Amendments to the Drawings:

The attached drawings sheets includes a changes to Figs. 5, 6, 7, 14, 15, 16, 17, 18 and 19. These sheets replace the originally filed sheets of Figs. 5, 6, 7, 14, 15, 16, 17, 18 and 19.

DOCKET NO.: RCOH-1039USCON1
Serial No.: 10/730,602
Amdt. dated March 5, 2004
Continuation Application of parent application 09/955,643
Annotated Version

FIG.5

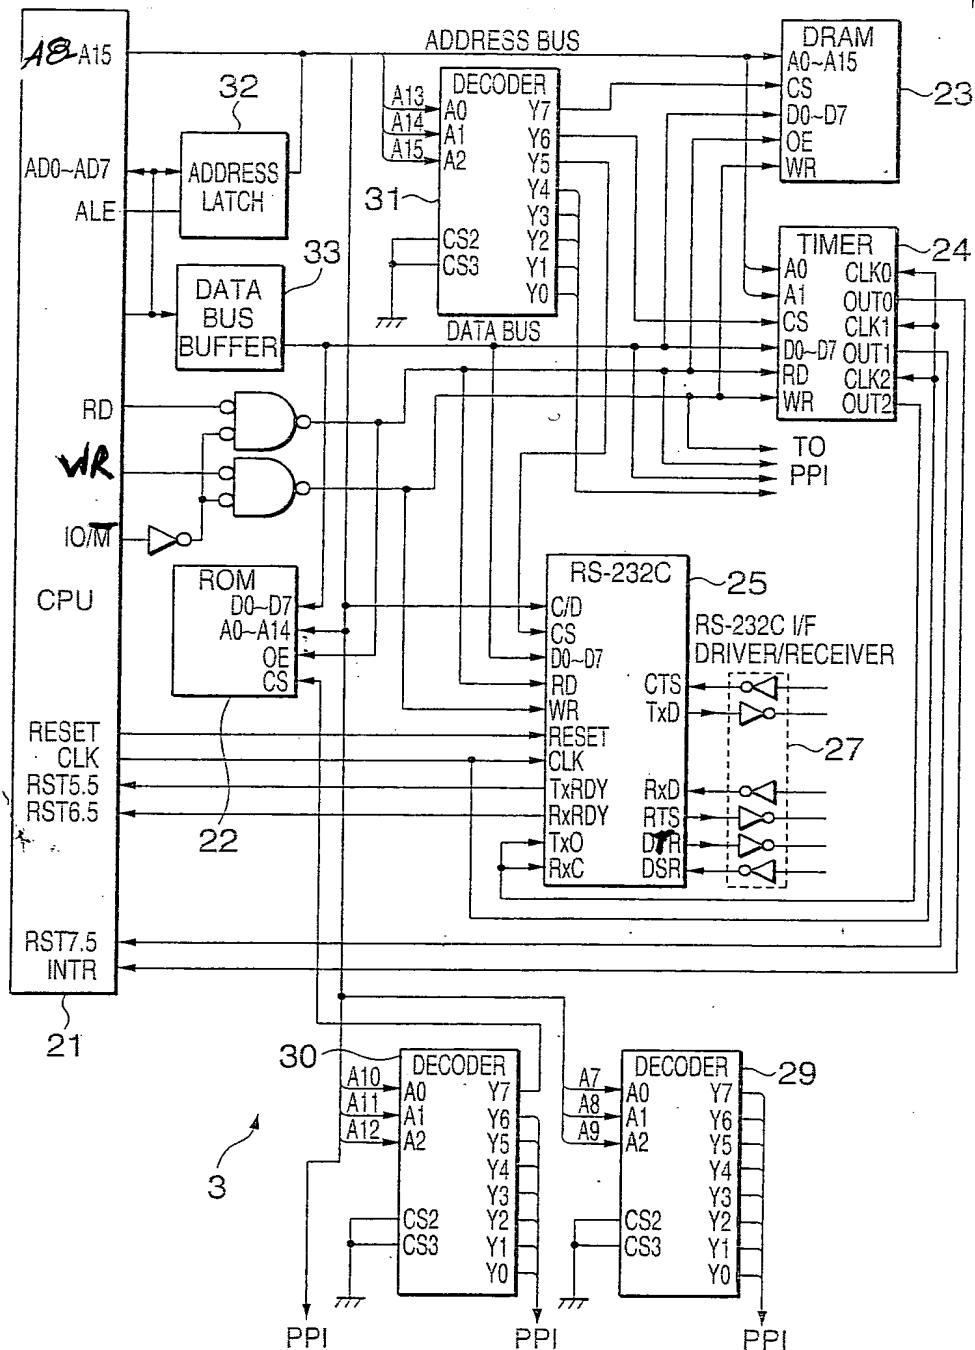
In Fig. 5, element 21, please change "A13" to --A8--. Also in Fig. 5, element 21, please add "WR" under "RD. In Fig. 5, element 21, please "IO/M" to --IO/M--. Also in Fig. 5, element 25, please change "DYZ" to --DTR--.

FIG.6

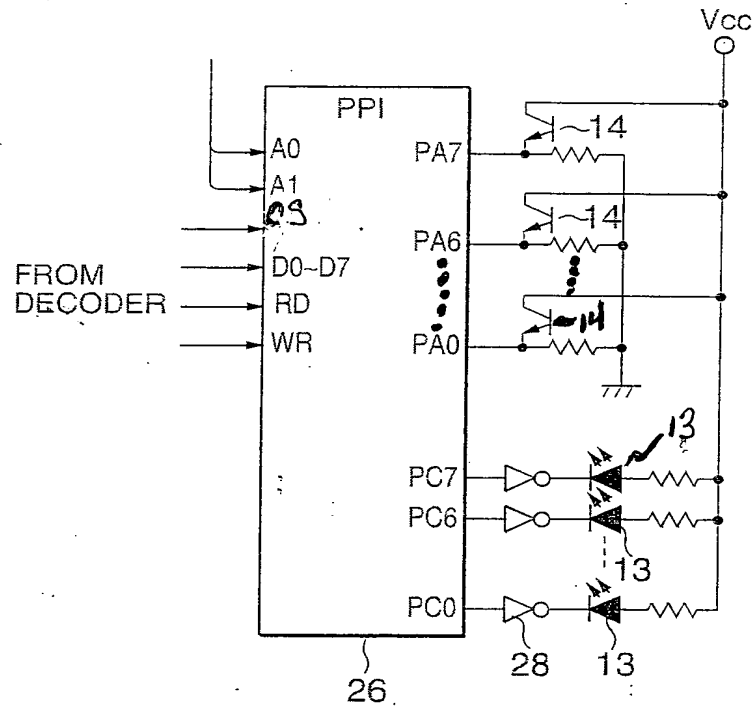
In Fig. 6, element 26, please change "OS" to --CS--. Also in Fig. 6, element 26, please place "...." between PA6 and PA0 as shown in red. In Fig. 6, please add reference numbers "13" and "14" to the drawing. Please also add "...." between the middle and bottom elements as referenced by the reference numbers 1-14.

FIG. 7

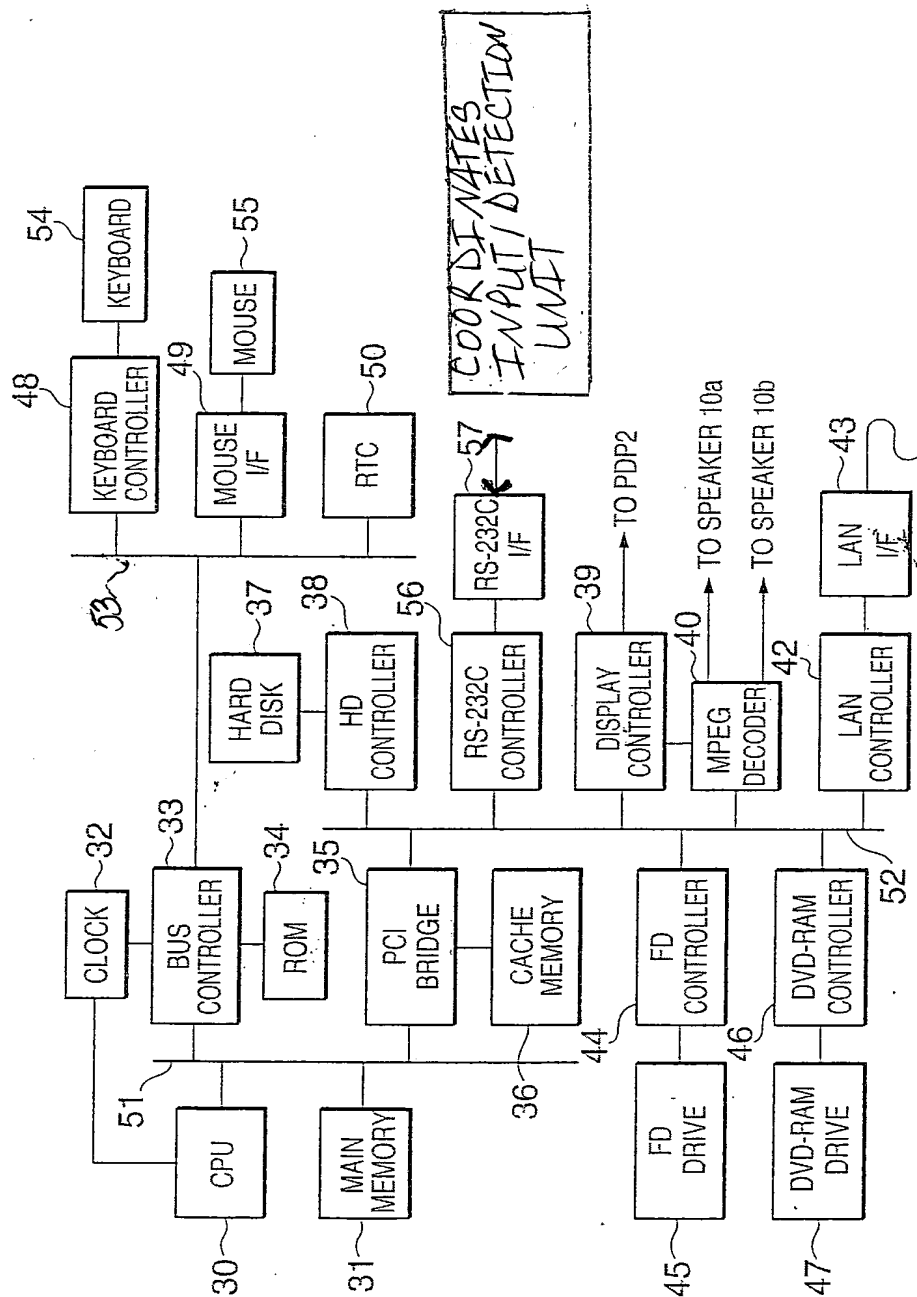
In Fig. 7, please add reference number "53" to the drawing. Also in Fig. 7, outside of element 57, please change the line to a double headed arrow and add a box for a new element at one end of the double headed arrow containing "COORDINATES INPUT/ DETECTION UNIT."

FIG.14

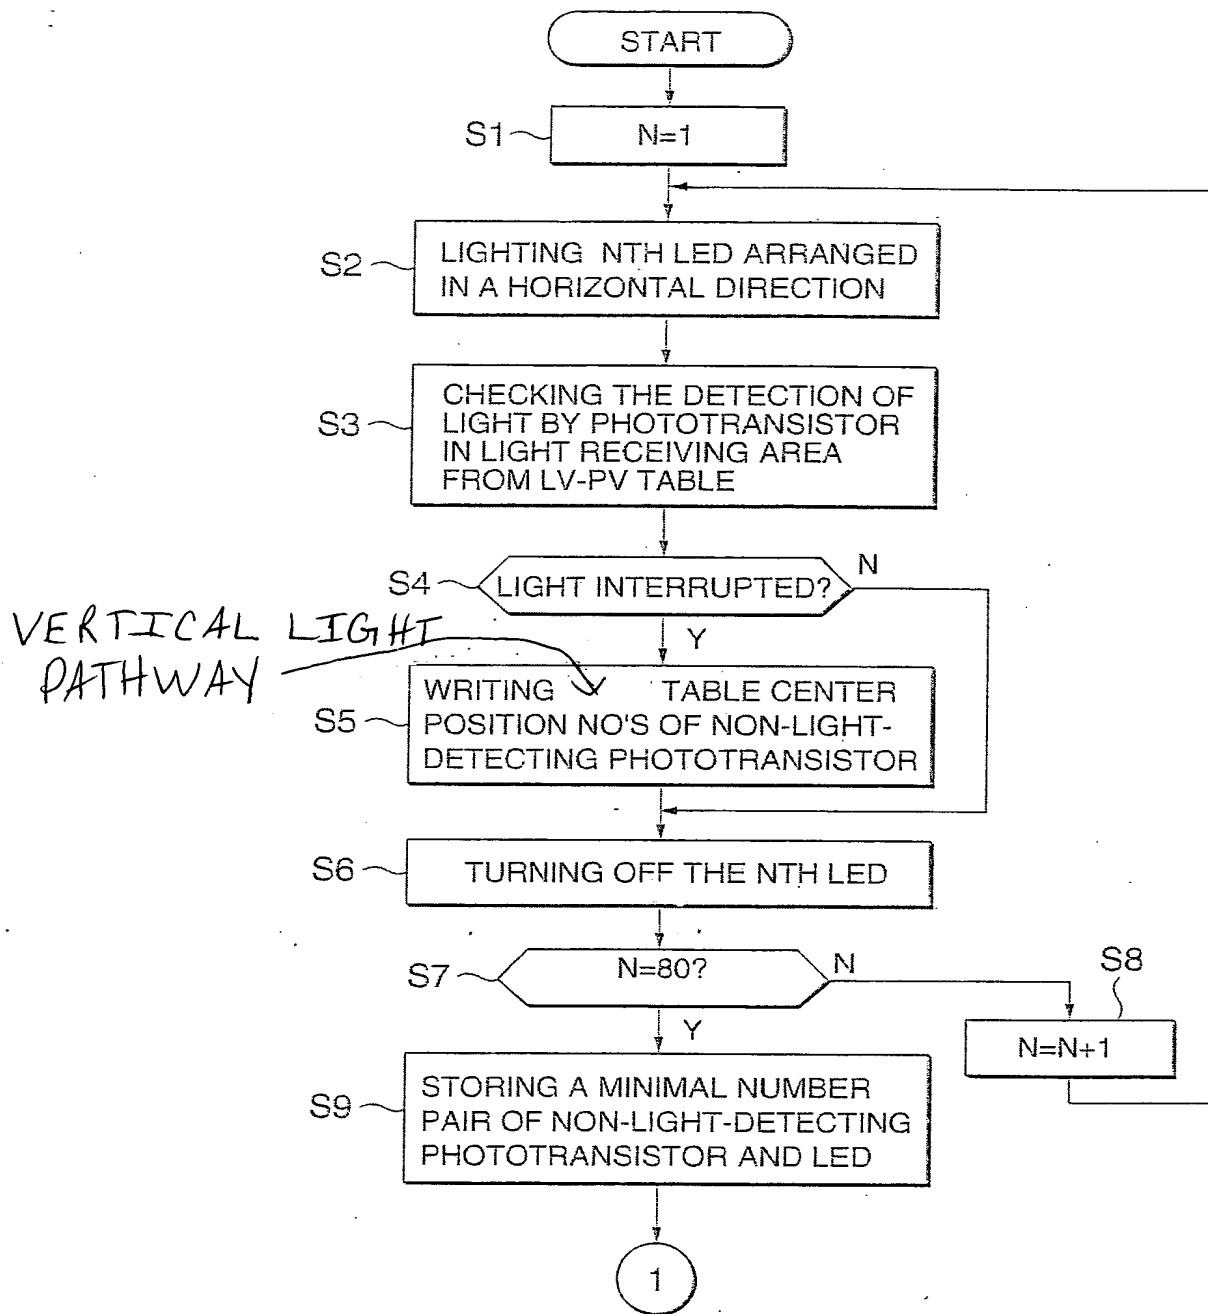
In Fig. 14, step S5, please delete "LV-PV" and insert --VERTICAL LIGHT PATHWAYS--.

FIG.15

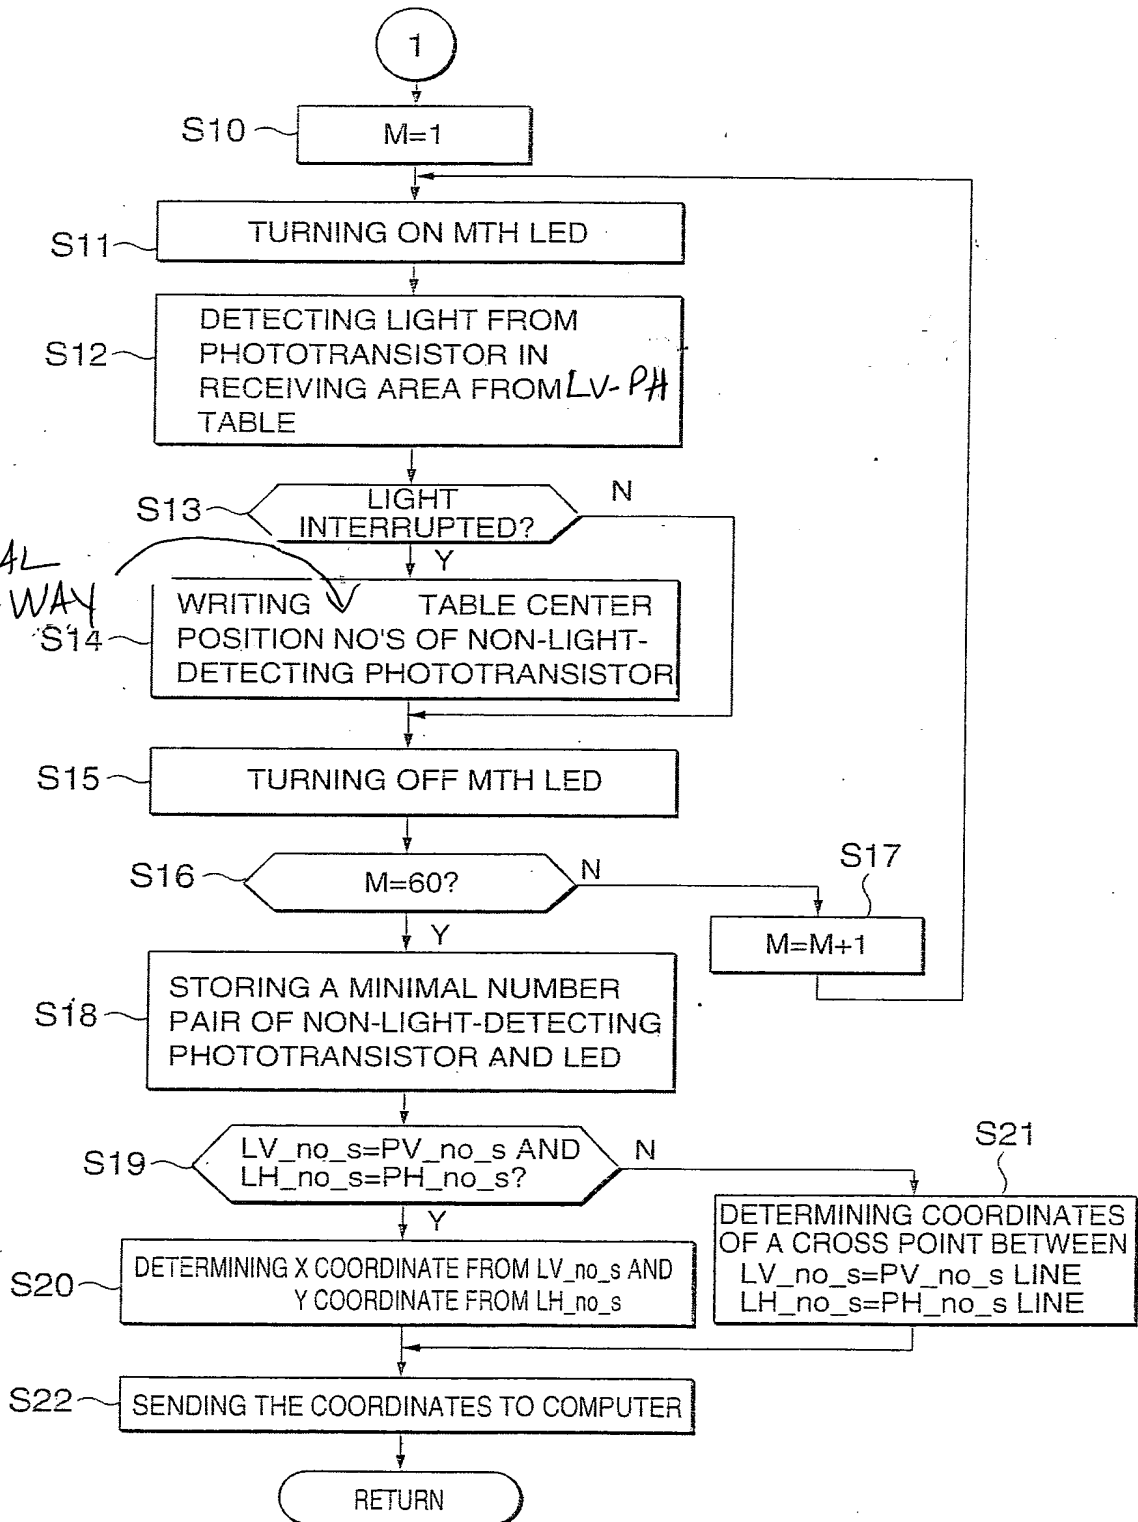
In Fig. 15, step S12, please change "LV-PV" to --LV-PH. Also in Fig. 15, step S14, please delete "LV-PV" and insert --HORIZONTAL LIGHT PATHWAYS--.

FIG.16

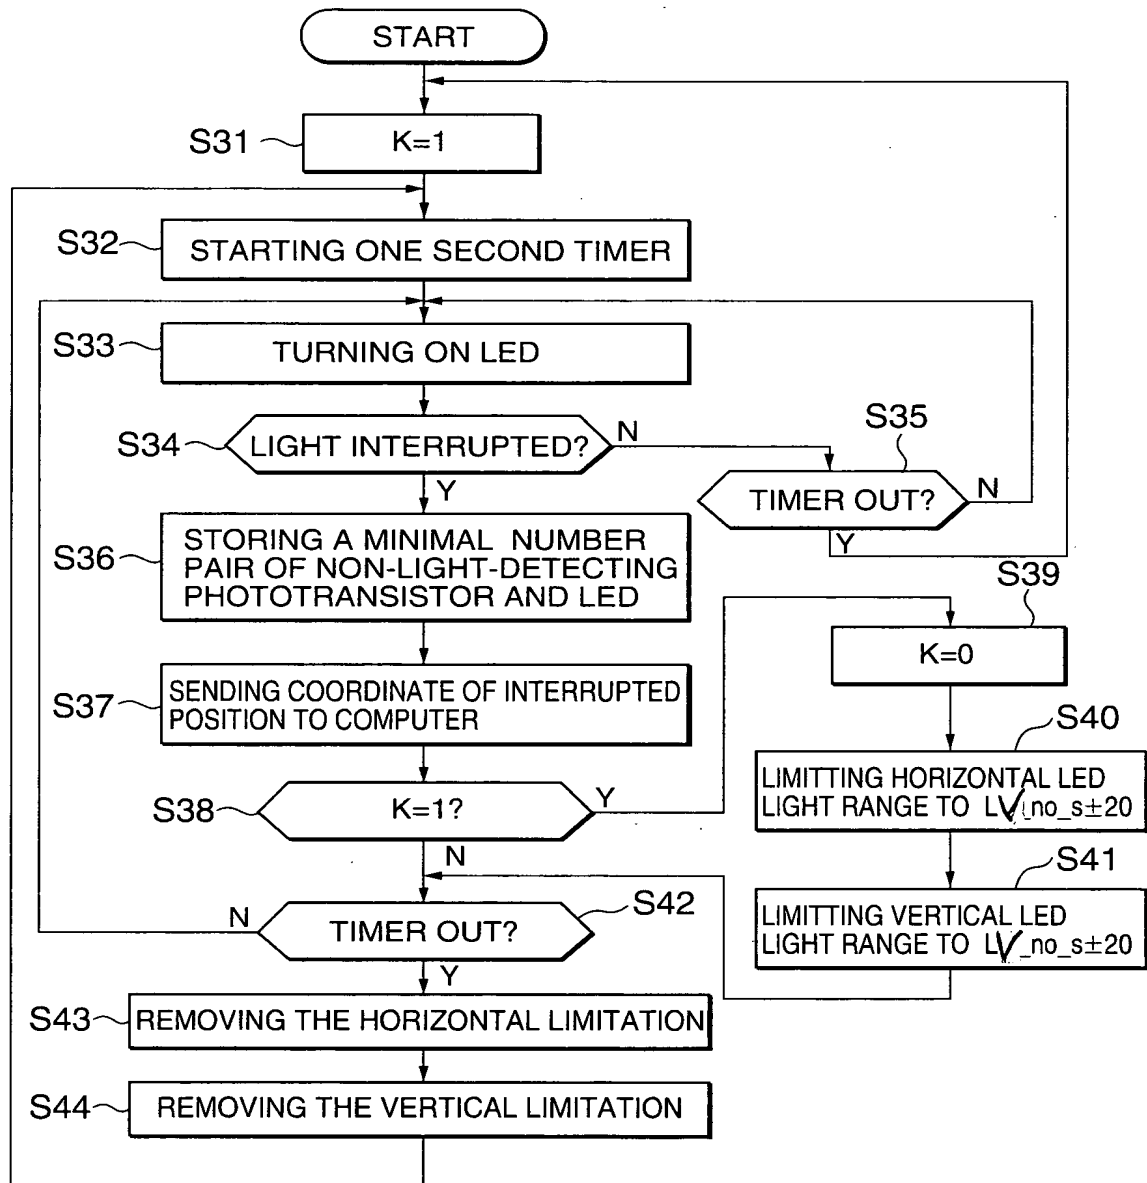
In Fig. 16, steps S40 and S41, please change "LH" to --LV--.

FIG.17

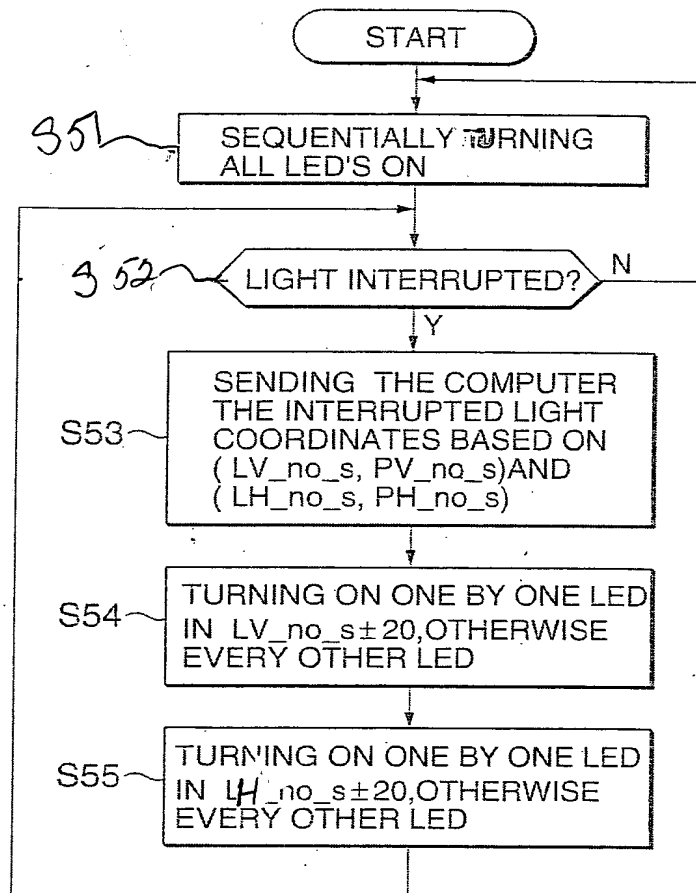
In Fig. 17, please add step --S51-- and --S52-- and please change "LF" to --LH-- in step S55. Please add space between "Sequentially" and "Turning" in step S51.

FIG.18

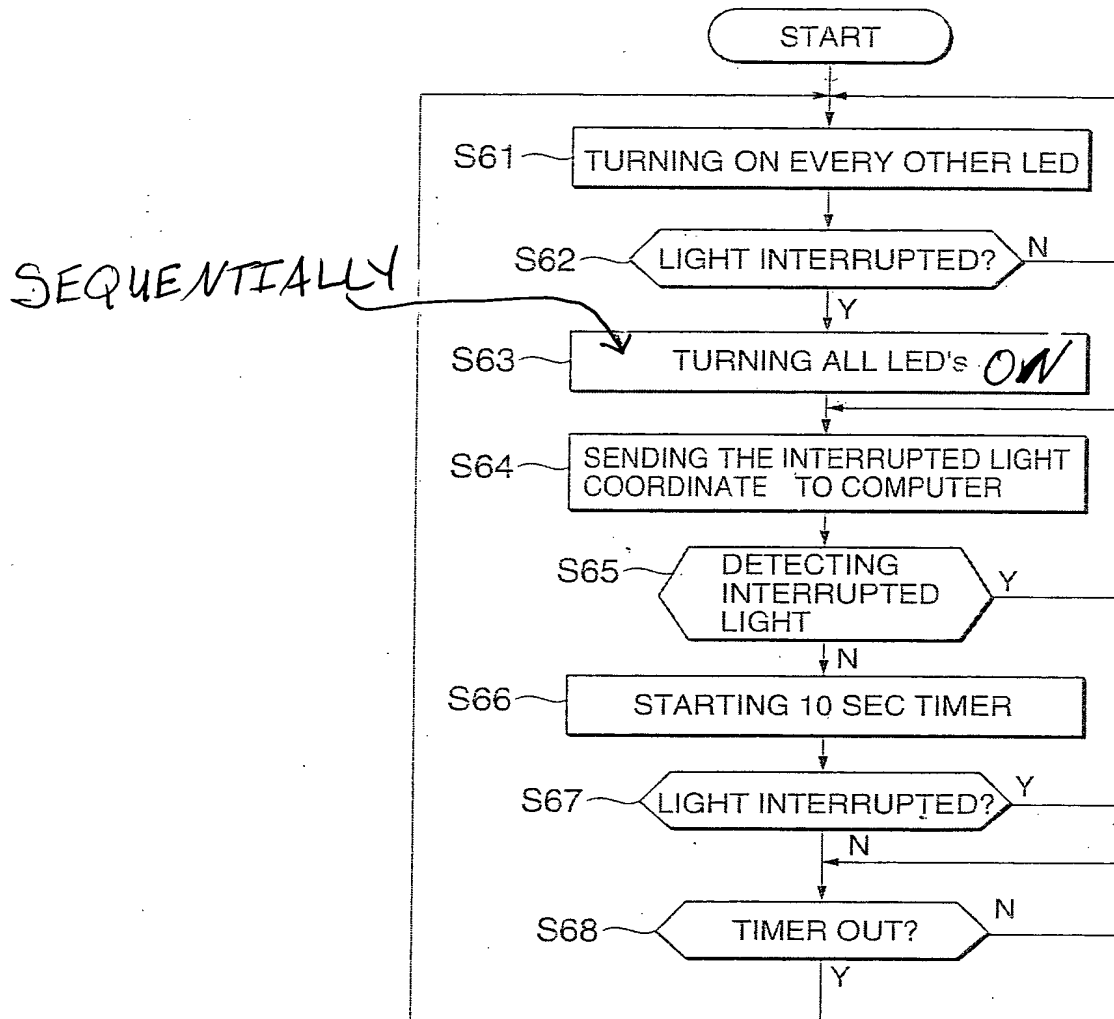
In Fig. 18, step S63, please add --SEQUENTIALLY-- before "TURNING" and --ON--after "LED's." In the step S64 please change "COORDINATES" to --COORDINATE--.

FIG.19

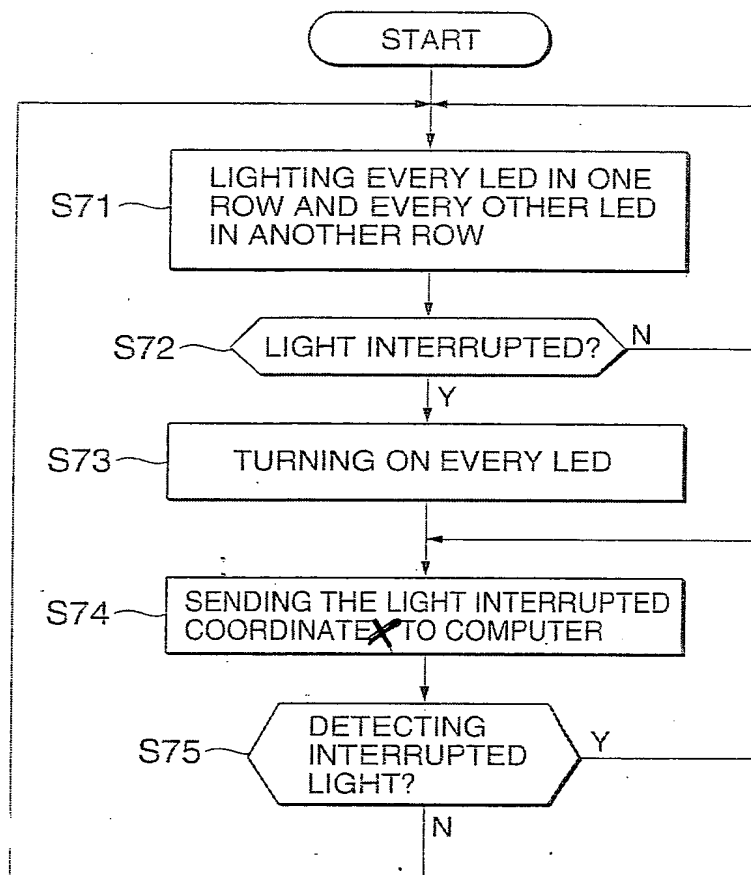
In Fig. 19, step S74, please change "COORDINATES" to --COORDINATE--.
